**From:** [John Ellis](#)  
**To:** [Cates, David](#)  
**Cc:** [Kalman, Kenneth](#); [Downs, Brittany R.](#)  
**Subject:** [External\_Sender] Re: Questions about raffinate disposal  
**Date:** Wednesday, September 09, 2015 5:03:24 PM  
**Attachments:** [SFC responses to questions from David Cates.docx](#)  
[FIGURE A R5.pdf](#)

SFC responses to questions from David Cates – ODEQ

PROJECT  
SEQUOYAH SITE DISPOSAL CELL

TITLE  
PROPOSED MATERIAL CELL LOCATION

FIGURE A

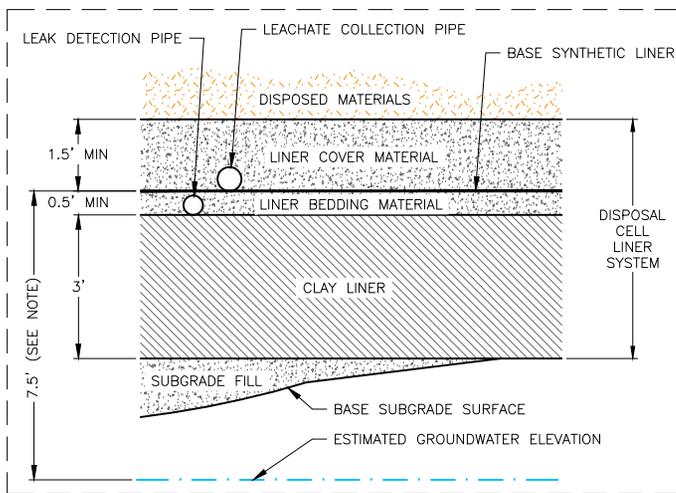
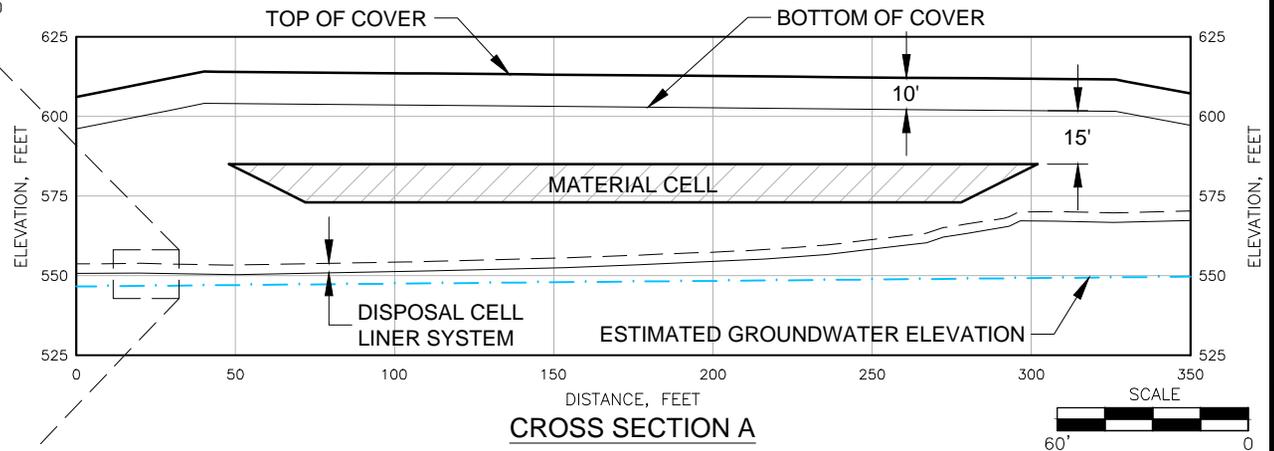
4. Where will the sacks be placed within the cell? Distance to bottom liner? Distance to top of cover?

The sacks will be placed in the north central part of the Phase III portion of the cell. Distance to the bottom HDPE liner will vary from x feet to y feet (the bottom of the Phase III cell base is sloped to the west to assure drainage of leachate to the collection point. The distance from the top of the raffinate bags to the top of the cell cover will be a minimum of 23 feet, which is the thickness analyzed in the Reclamation Plan. The attached drawing (Figure A R5) depicts the approximate location of the raffinate bags, both in plan and elevation views.
